Date: 17 November 2023
Our ref: 456687
Your ref: TR010032

**Application by National Highways for an Order Granting Development Consent for the Lower Thames Crossing
Natural England's response to Deadline 7
Natural England User Code: 20034784**

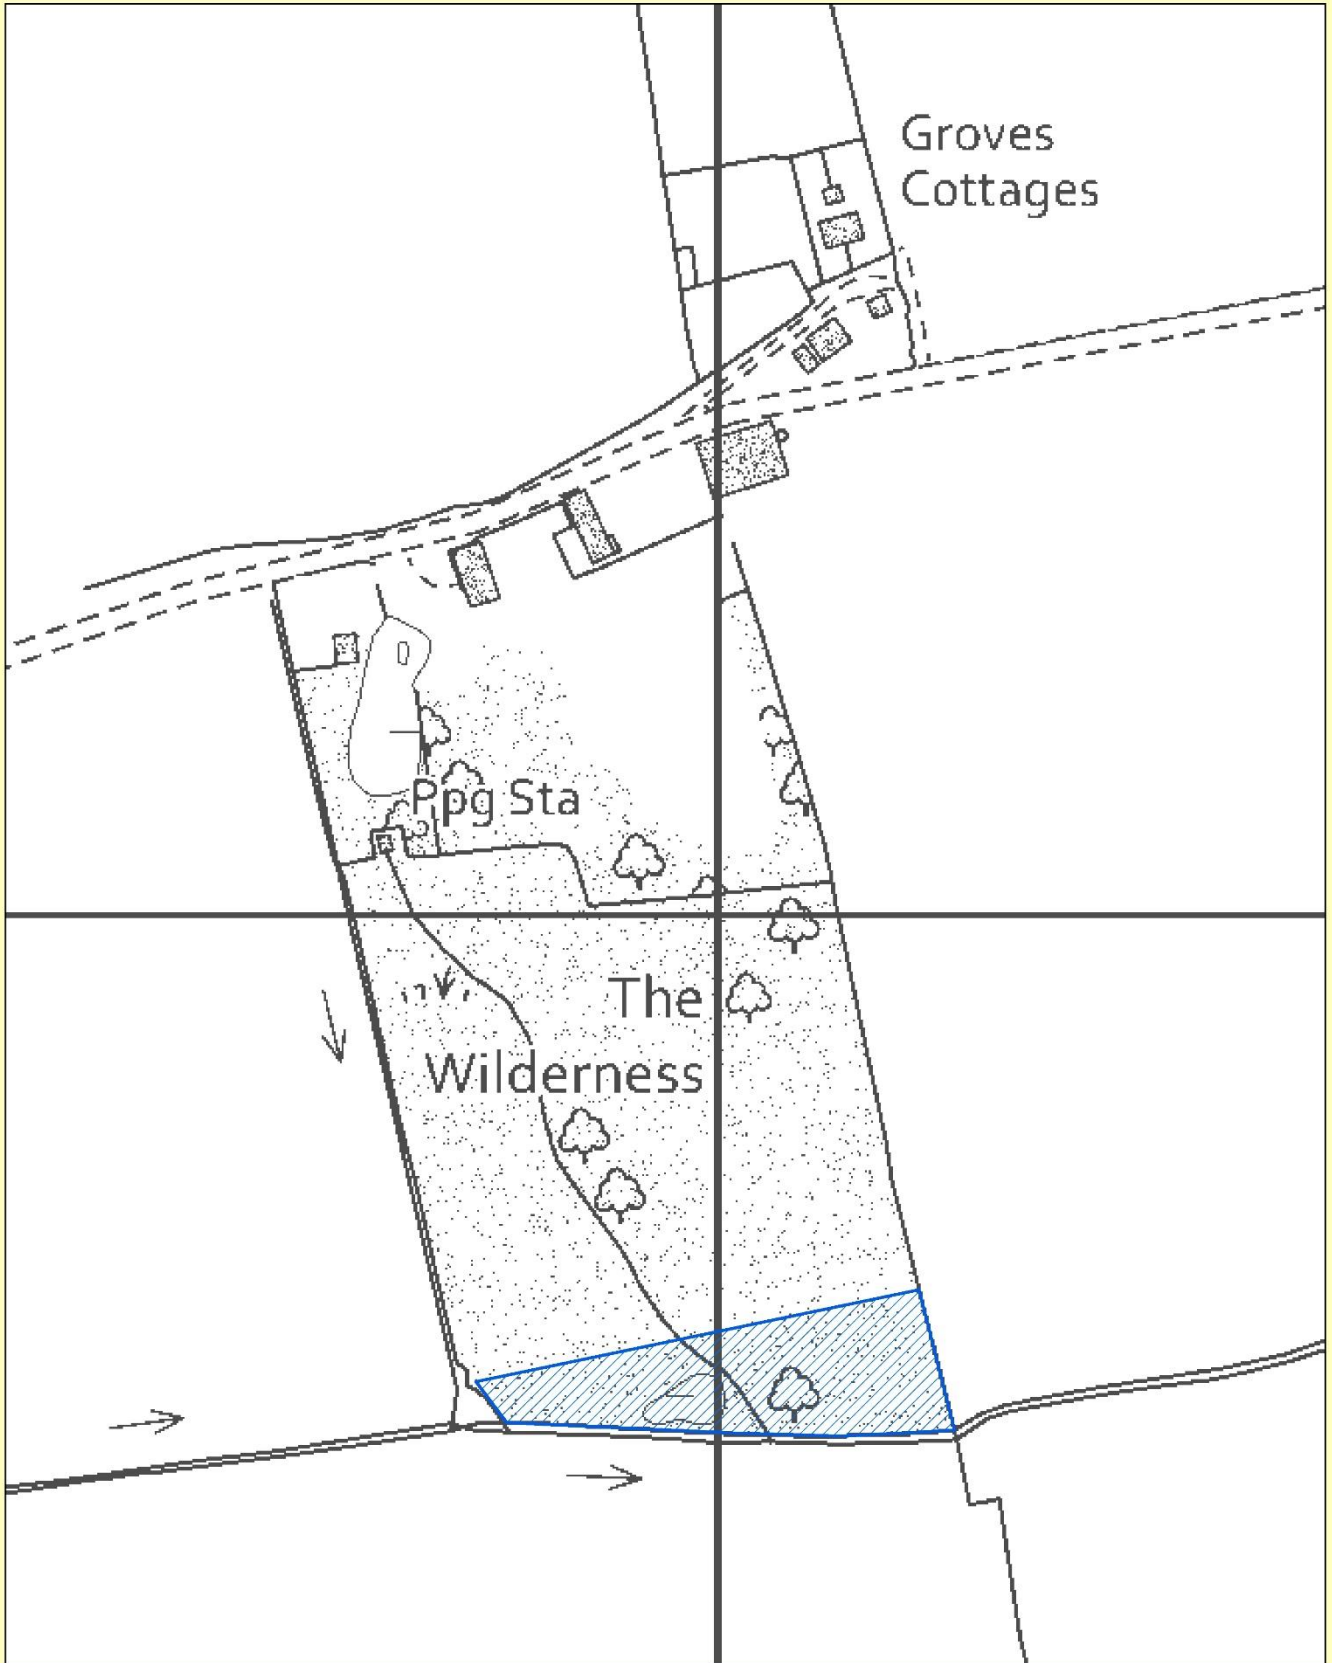
- 5.4 The southern section is classed as ancient semi-natural woodland; the northern section is classed as long-established woodland.
- 5.5 The polygon will be split and the Wilderness added to the pending Ancient Woodland Update layer. We have included a plan showing the area of ancient woodland below.

- 5.6 Natural England does not endorse the loss of and damage to ancient woodlands, which are afforded significant protection in planning policy in both the National Planning Policy Framework (Paragraph 180(c) and the National Policy Statement for National Networks (Paragraph 5.32):
